TO: Mercedes-Benz Dealer Principals, General Managers, Sales Managers, Service Managers, Parts Managers	FROM: Gregory Gunther, Department Manager, Vehicle Compliance and Analysis, Engineering Services
RE: Recall Campaign Launch Notification Check the 48V Ground Connection MY20-22 GLE-Class and GLS-Class (167 platform)	DATE: 6/10/2022

Campaign No. 2022040017, June 2022

SUBJECT: **Model GLE-Class and GLS-Class (167 platform)**
Model Year 2020-2022

Check the 48V Ground Connection

Figure 1

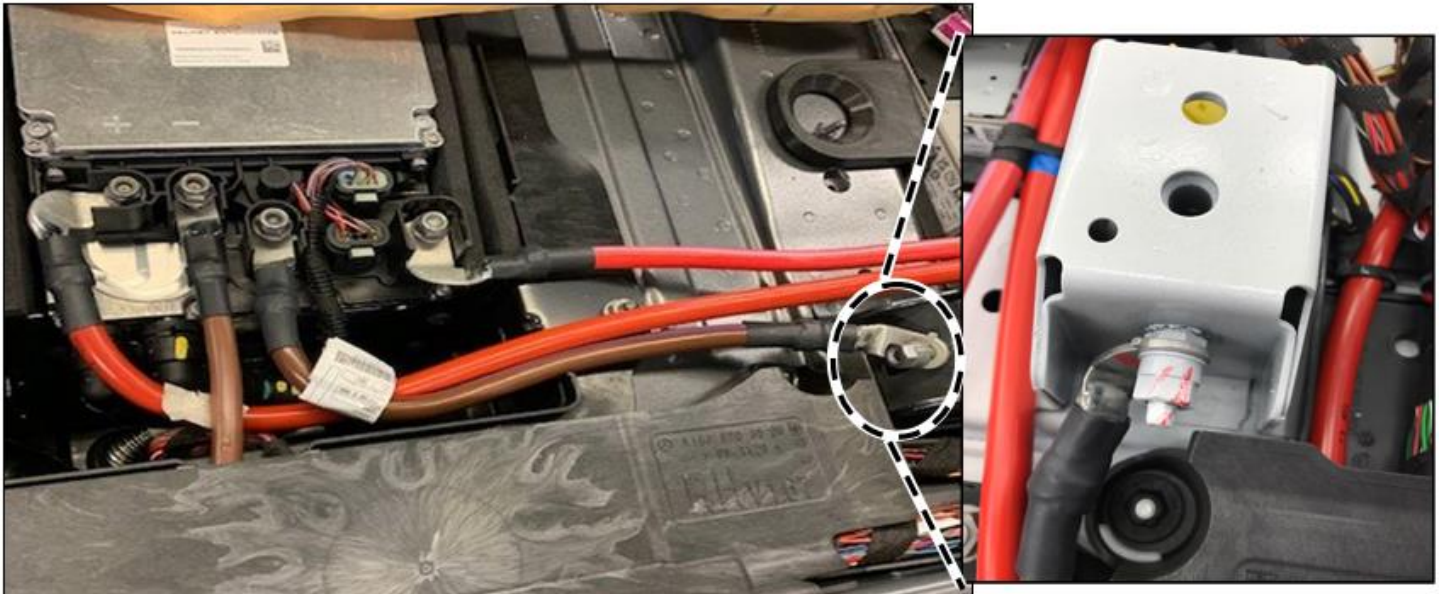
5. Expose right rear floor covering to the extent that the "W106/1" ground point is accessible for the electrical wiring harness of the 48 V on-board electrical system battery (**Figure 1**).

7. Disconnect and check threaded connection of the electrical wiring harness of 48 V on-board electrical system battery of "W106/1" ground point on the body (**Figures 1 and 2**).

- i** Ensure there are no traces of thermal overload, arching, or scaling.
 - i** Figure 2 is showing an image that is **not** OK!

- a. If **traces of debris/arching** are **present** on the wiring harness to "W106/1" ground point: :
Carry out **work procedures A and B**.
- b. If **traces of debris/arching** are **not** present on the wiring harness to "W106/1" ground point:
Carry out **work procedure B**.

1. Replace the electrical wiring harness from the "W106/1" ground point to 48 V on-board electrical system battery.
 - i** Thoroughly clean area of debris/arching traces.
 - i** If the ground bolt also shows signs of arching or damage, the ground bolt must be replaced.
 - i** If traces of arching or damage are present at the surrounding component parts, such as the floor covering, these component parts must be replaced.

1. Connect electrical wiring harness of the 48 V on-board electrical system battery to "W106/1" ground point.
 - i** Torque of the electrical wiring harness "W106/1" ground point threaded connection **Nm** 16!
 - i** During installation of the electrical wiring harness to the "W106/1" ground point, a clean contact surface of the cable lug from the electrical wiring harness and the "W106/1" ground point shall be ensured.
2. Assemble in reverse order.
3. Connect XENTRY Diagnosis.
4. Erase fault memory.
5. Disconnect XENTRY Diagnosis.
